1965 Corvette: Service Bulletin: Turn Signal Switch - Failure to Cancel

Subject: Turn Signal Switch - Failure to Cancel

Bulletin Number: DR #706, Section XII

Date: October 26, 1964

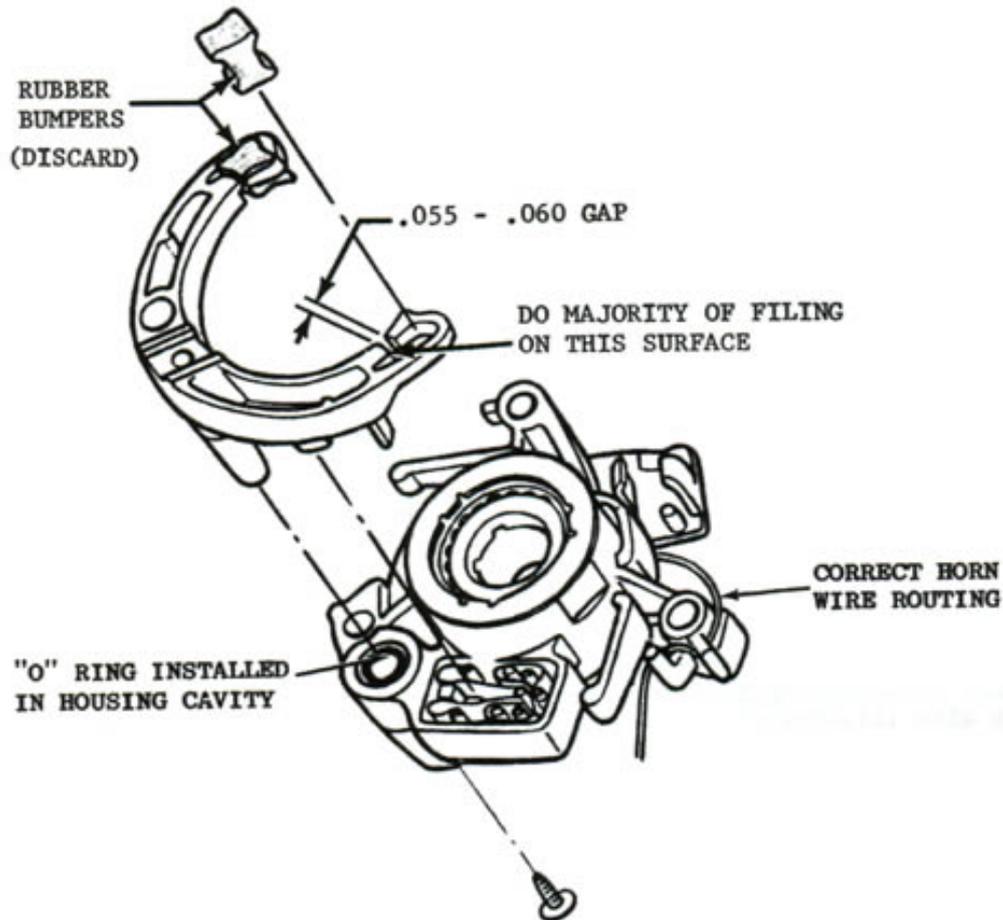
It should also be noted that if for any reason the actuator lever is removed from the switch body, the "O" ring must be placed in the body cavity (as shown on the attached sketch) when reinstalling the lever. The correct horn wire routing is also illustrated in the sketch.

2. Remove and discard both rubber bumpers from the actuating plate (see sketch).
3. Using a small file, such as an ignition point file, open the gap in the cancelling pawls to .055/.060 (rework both sides). NOTE: After cleaning any flash from the moveable arm face, perform the stock removal from the stationary arm.
4. Blow out loose filings with air hose.
5. Replace the steering wheel, temporarily, and test the switch for cancelling.
6. If the switch now works correctly, reinstall the steering wheel. If the switch still fails to cancel, it will be necessary to replace the switch assembly (Part No. 910821).
